Hurricane Planning Commission Meeting Agenda

September 22, 2022
5:00 PM

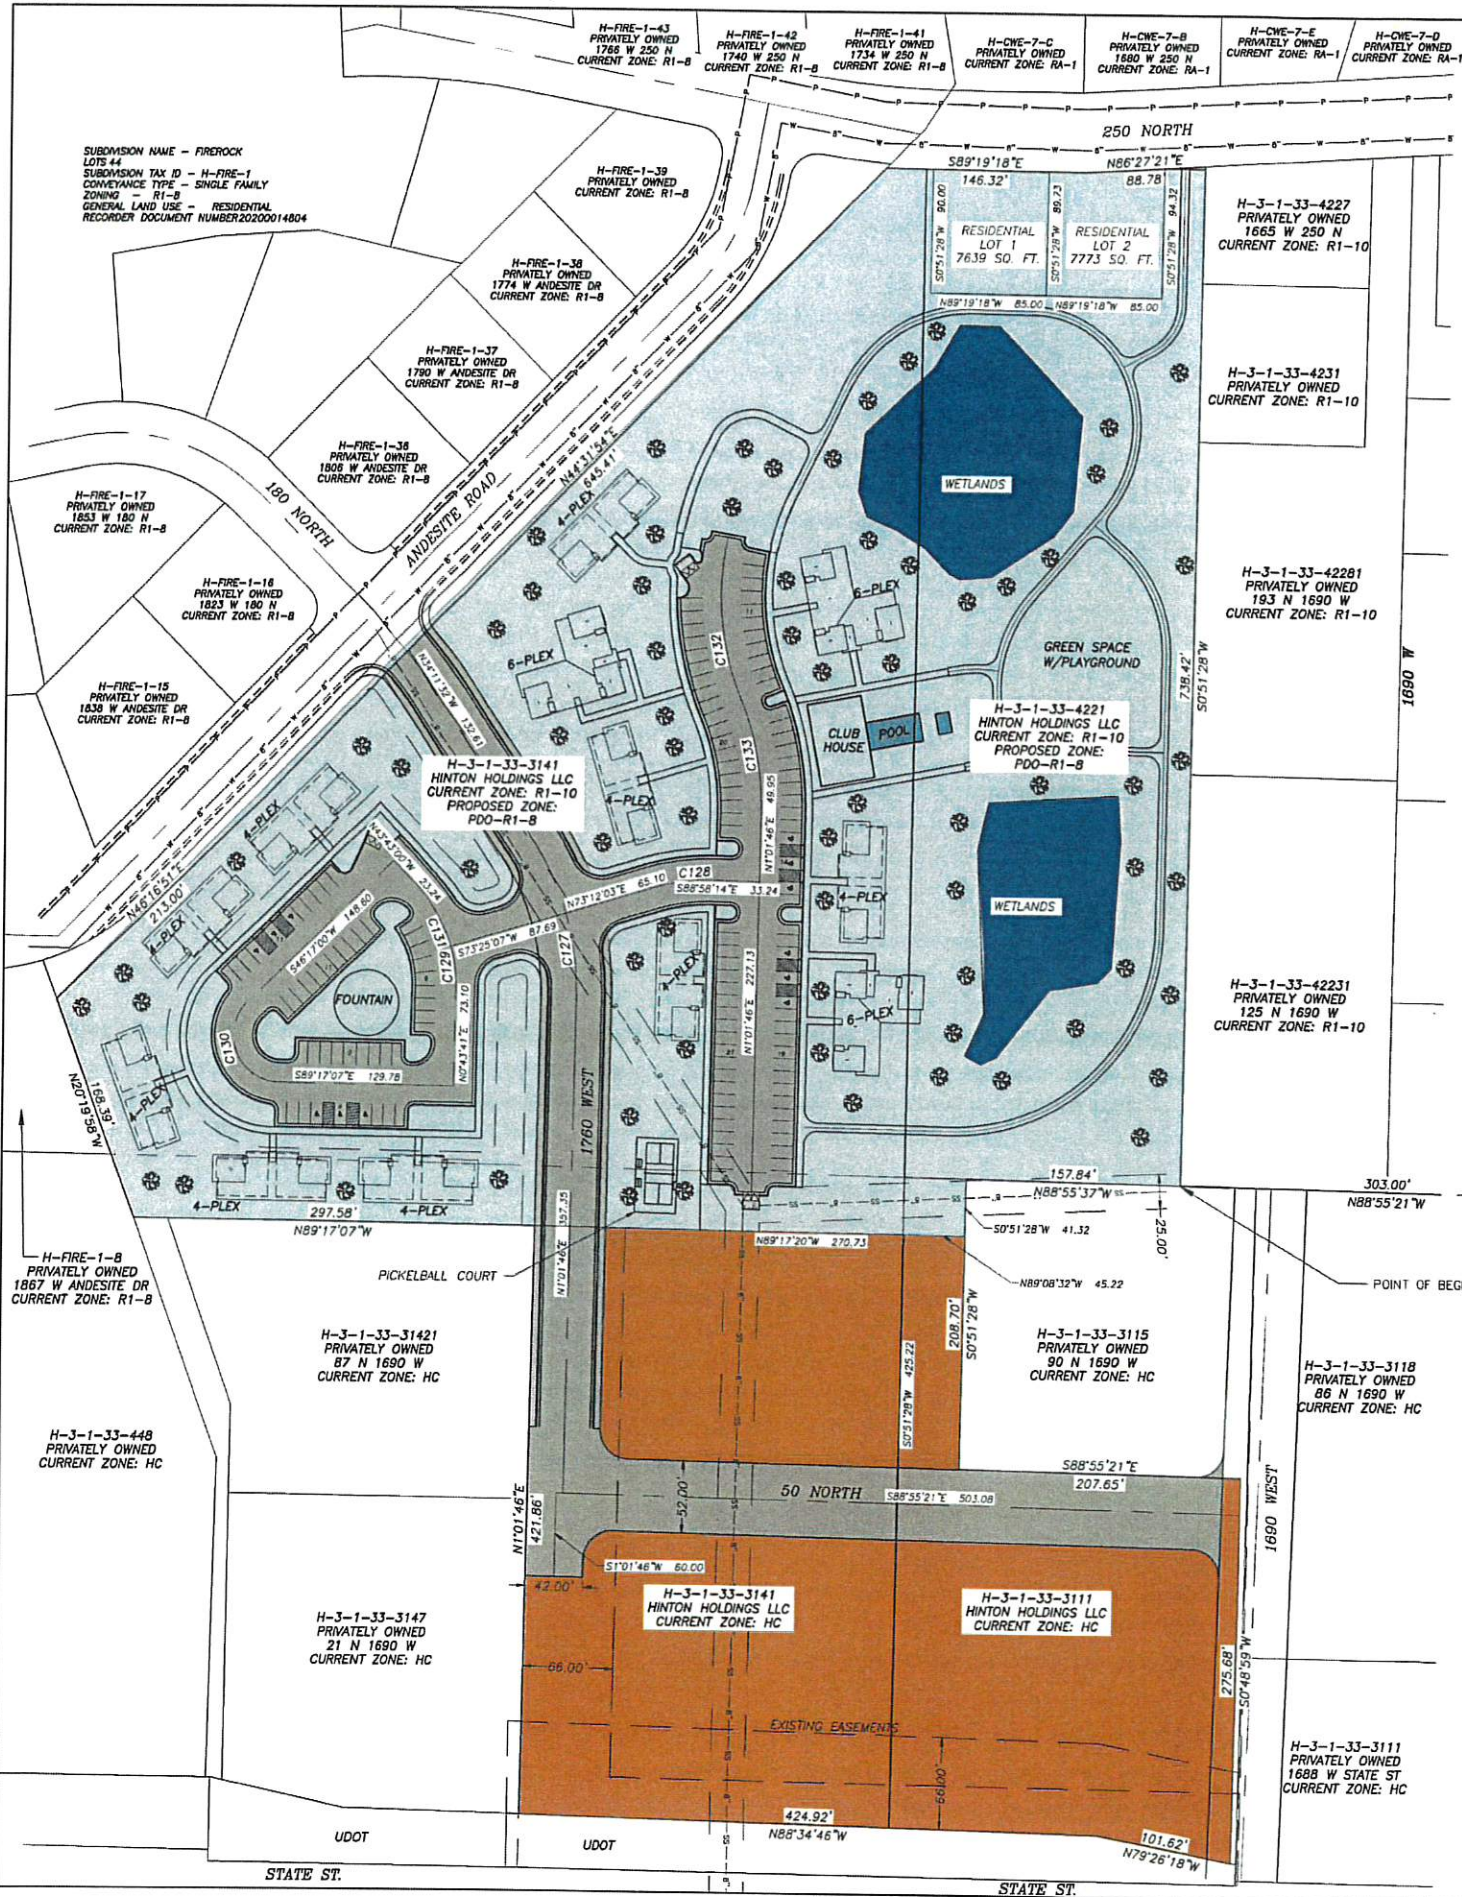
1. **Sewer:** No comments.
2. **Water:** No comments.
3. **Fire:** Okay with zone change. No parking signs required on turnaround in HC area.
4. **Engineering:** Interconnectivity is encouraged, however the extension of 180 N may not be feasible with the required grading. Check for double frontage lots. Check drainage plan. Lot 53 is in Zone AE floodplain. Coordination with neighbors required for development of 1690 W. The Transportation Master Plan doesn't show 100 N in this area however that might be desirable. Specific approval from the City Engineer is required for a street to end without a cul-de-sac turnaround. Additional information is needed. How long is the dead end street? What will the grading be like? Does the existing structure limit access?

5. **Streets:** Okay with zone change. Are the streets in the R1-8 zone private or public?
6. **Power:** Existing power line on the south side will need to be put underground. A fee of \$900 will be charged to the owner/developer to design the power system. This must be done before construction drawings. Load calculations for pool/rec area and commercial lots must be given before design. Easements need to be obtained and turned over to the city.

1. **Density:** The Preliminary Site Plan shows 52 units on 10.065 acres. This is a density of 5.16 units per acre. The max R1-8 PDO density is 4.4 units per acre. The applicant could ask for a density bonus; however at this time no density bonus has been requested.

2. The property owner to the west has come to city staff about an easement located on the south end of this property that would not allow it to be developed in the manner shown on the site plan. Staff is still investigating these claims at this time.

From: Eric Mcfadden <premier.design_eric@yahoo.com>
Sent: Tuesday, August 30, 2022 3:17 PM
To: Stephen Nelson; FRED HURRICANE CITY; Luke Godfrey; David Eves
Subject: Fox Meadows Estates Revised Layout
Attachments: FOX MEADOWS REVISED 8-30-22.pdf

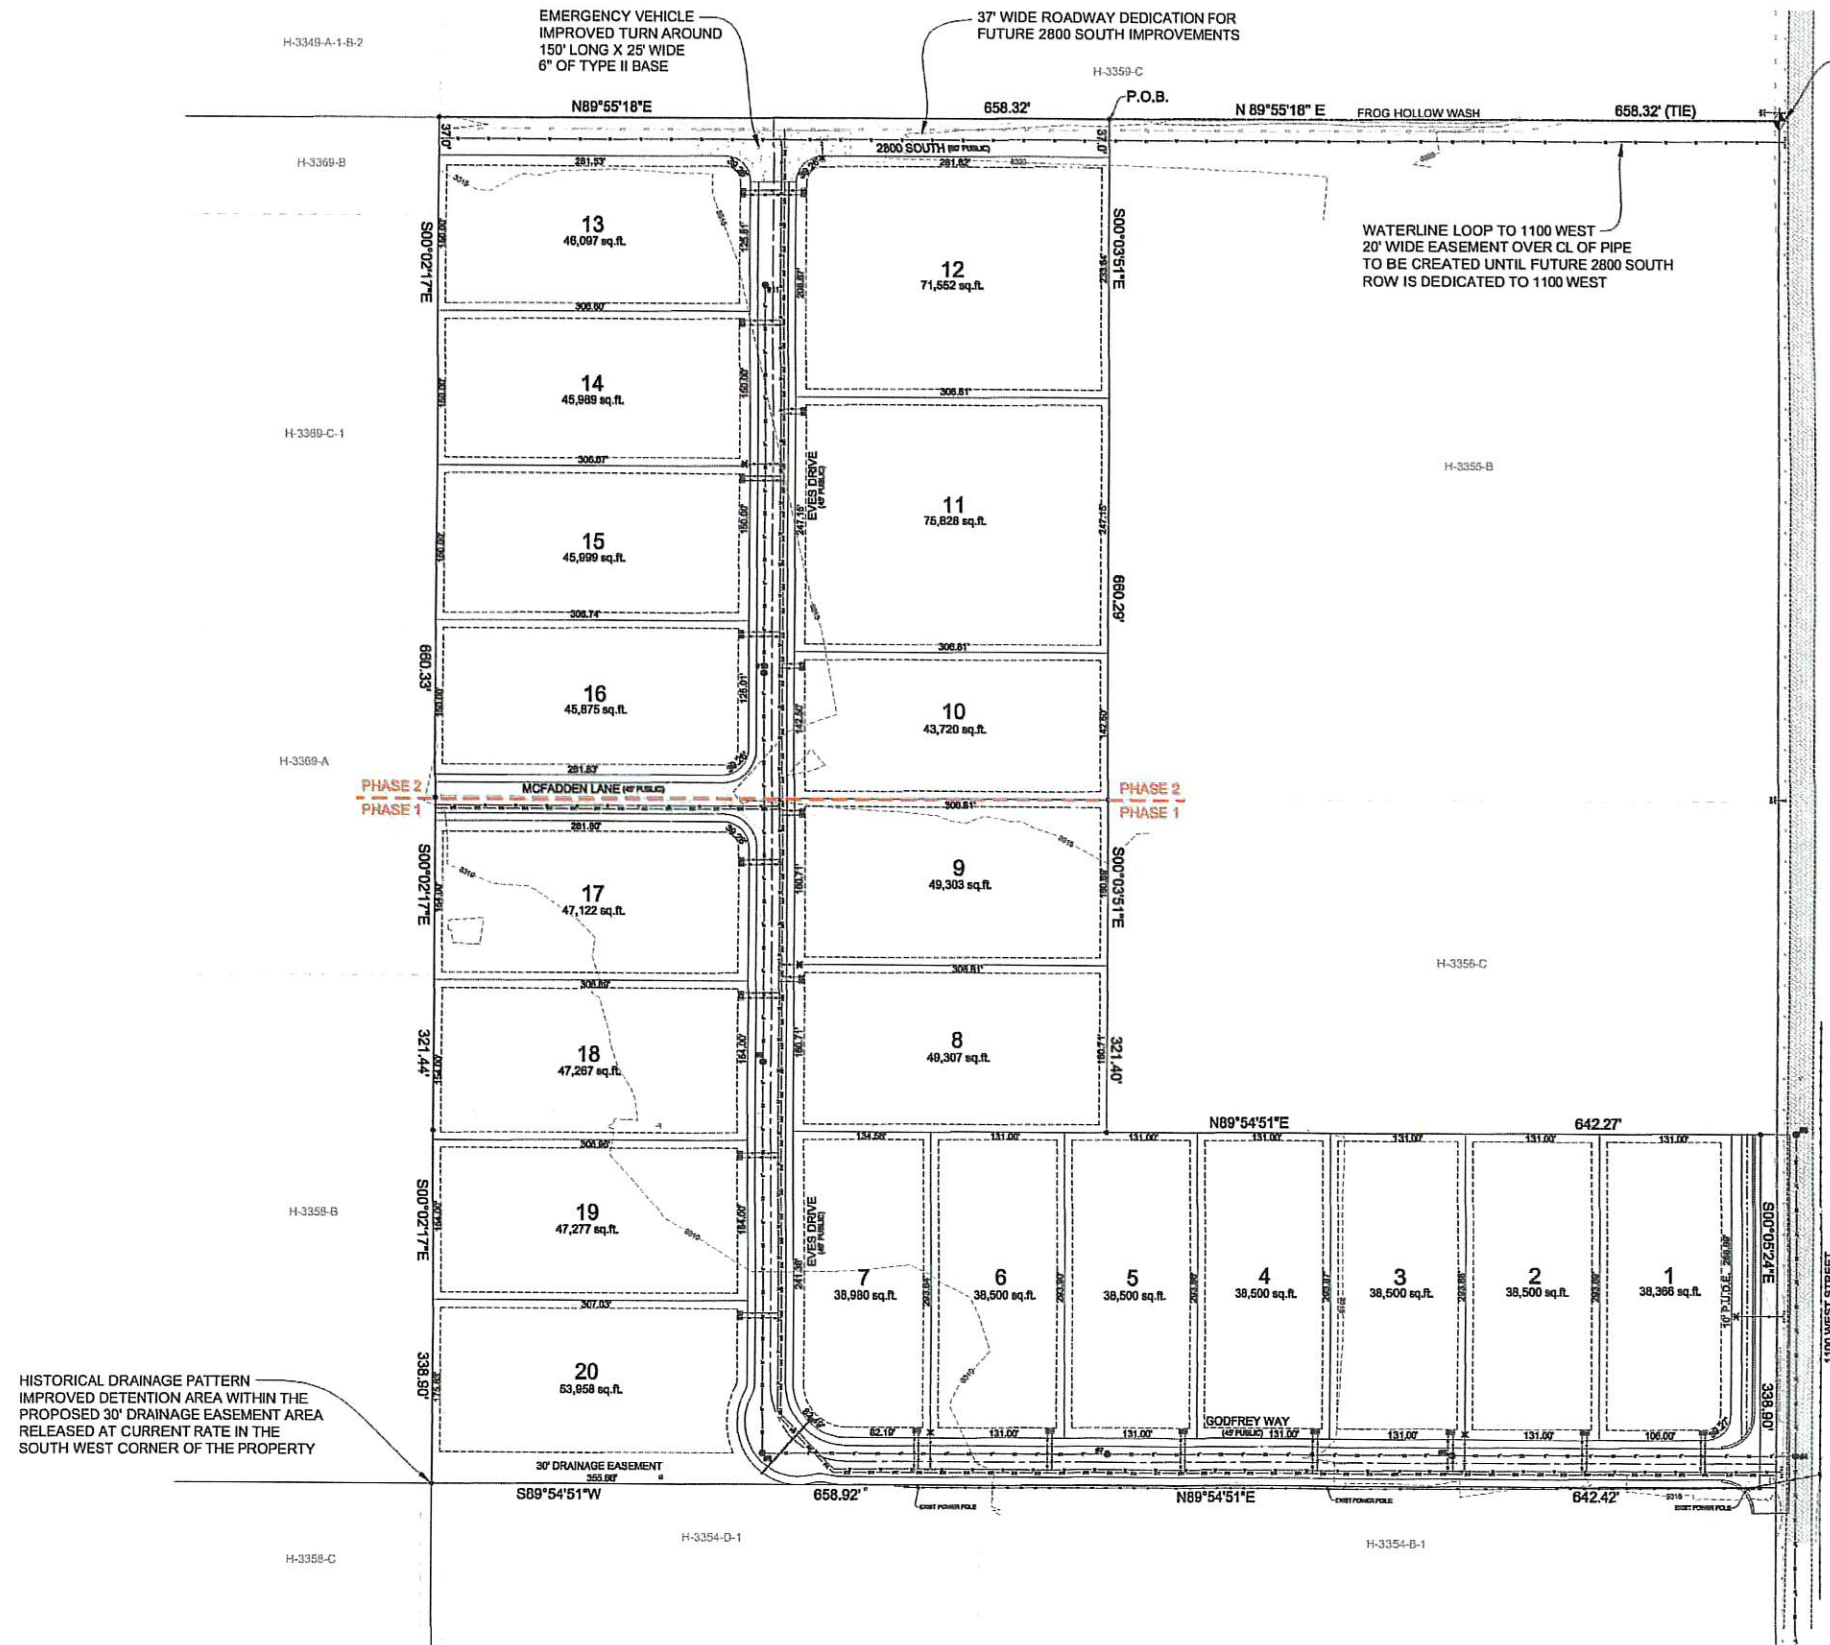
1. The new proposal does not align with the master plan roadway as shown on the transportation master plan. As staff met to discuss the new alignment there was general discussion about some real benefits about moving the roadway off the wash. However, there is also concern about moving a master plan roadway from the area, with no guarantee of future connections. Any major change of realignment would require a change in the Transportation Master Plan. Staff would recommend that an alternate master planned roadway be used in exchange for the future 2800 W.

2. The applicant is proposing to have the trail follow the wash. Planning staff generally like this idea, because it allows the trail to be located away from roadways and still provide better connections.

3. Staff has received concerns from adjacent property owners. The wash, which currently sits within the boundary of the subdivision, is being proposed to be moved north to have the center of the wash, placing some of the improvements and impact on adjacent property owners, which at the time of this report have not consented to this plan or indicated that they will. Lacking consent from the adjacent property owners, the full wash improvements will need to fall completely within the subdivision boundary.

6. The plat does not show any connectivity to the property to the east and west. The southernmost roadway and the centermost roadway should continue across the property Hurricane City Code states:

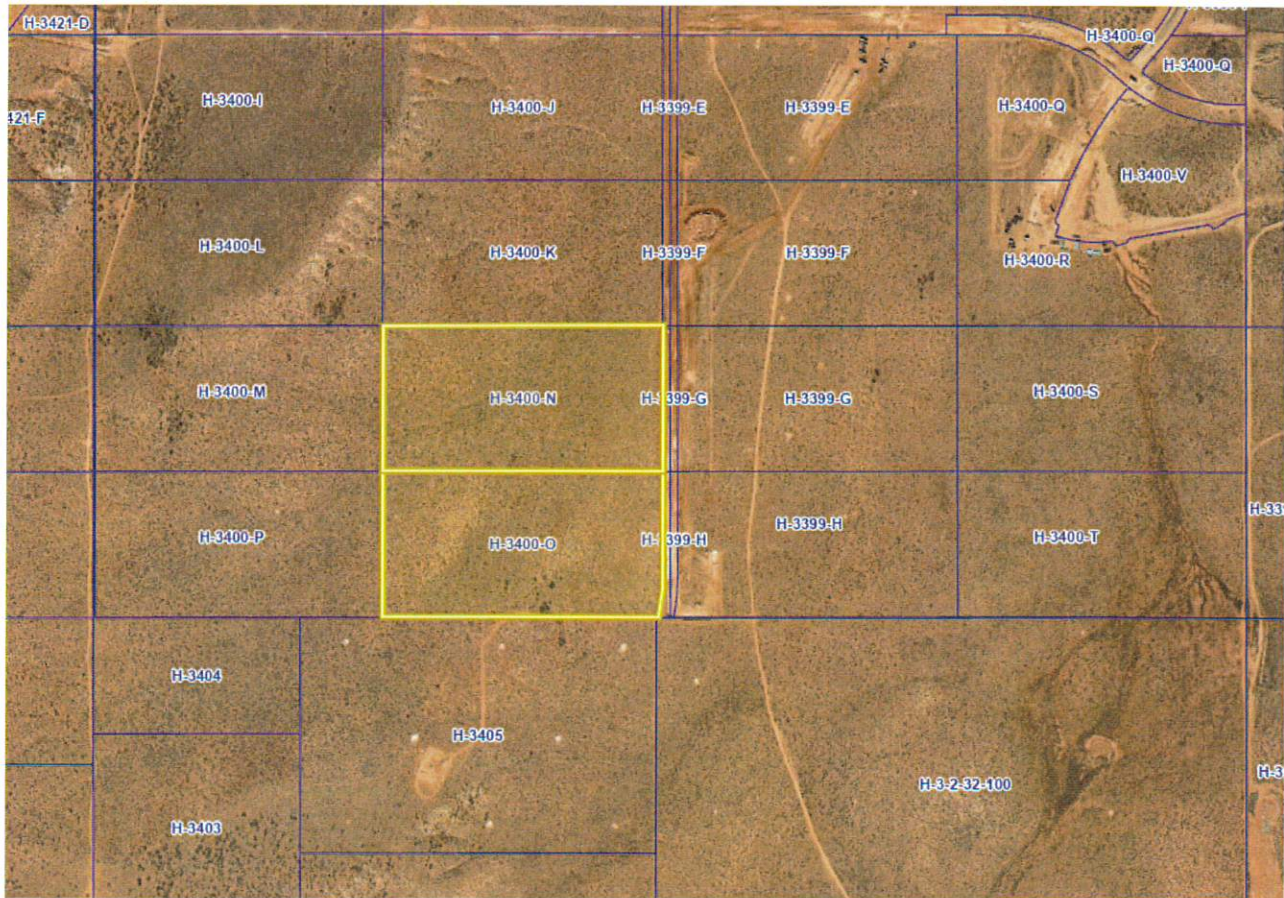
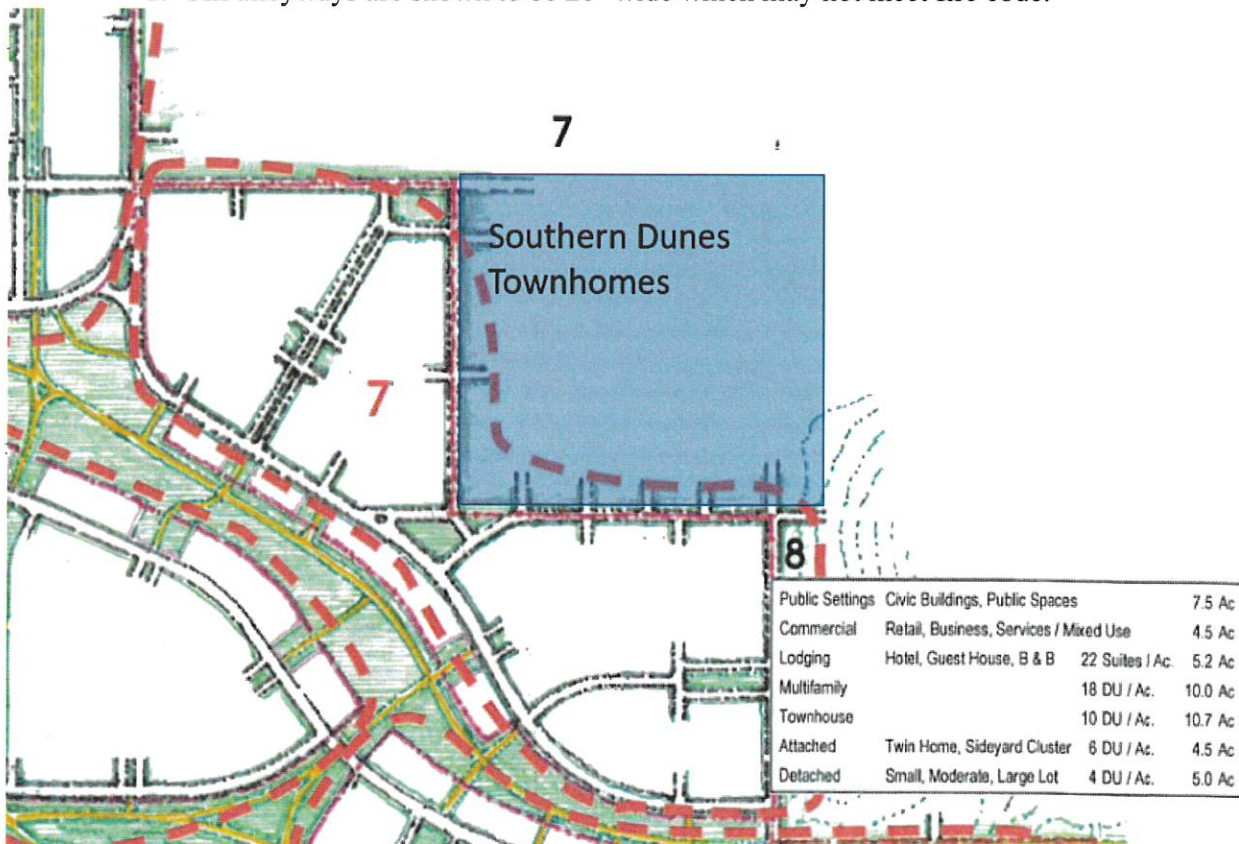
A couple of recommendations would be to have Road B connect all the way through the project. Have Road F make a connection to the North. Have Road D connect to the west.

- d. All alleyways are shown to be 20' wide which may not meet fire code.

Hurricane City slope map

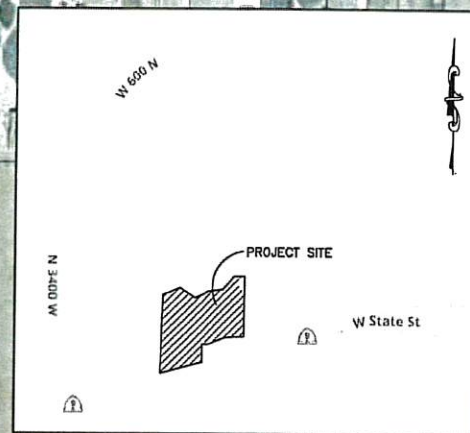
6. There are some steep slopes on the property that will need to be accounted for in the design. Sensitive lands applications will most likely be needed at the preliminary plat stage
